Applies To: 2007–08 TL – Check the iN VIN status for eligibility

June 27, 2012

**Safety Recall: 2007–08 TL Power Steering Feed Hose Leak**  
(Supersedes 12-020, dated May 17, 2012, to revise the information marked by the black bars)**REVISION SUMMARY**

27. Remove the center bolt from the transmission lower mount:

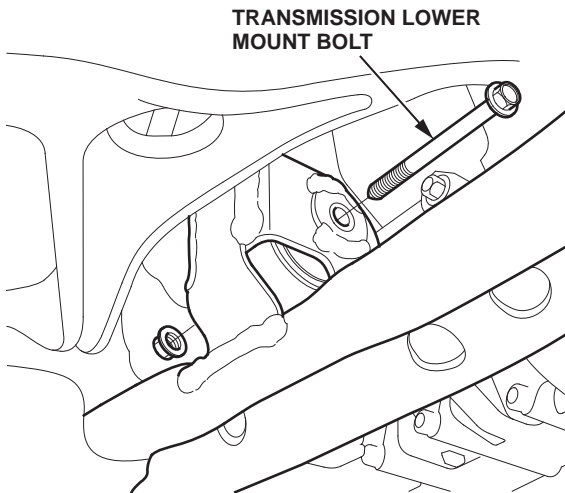
Under REPAIR PROCEDURE, the image for step 27 was changed.
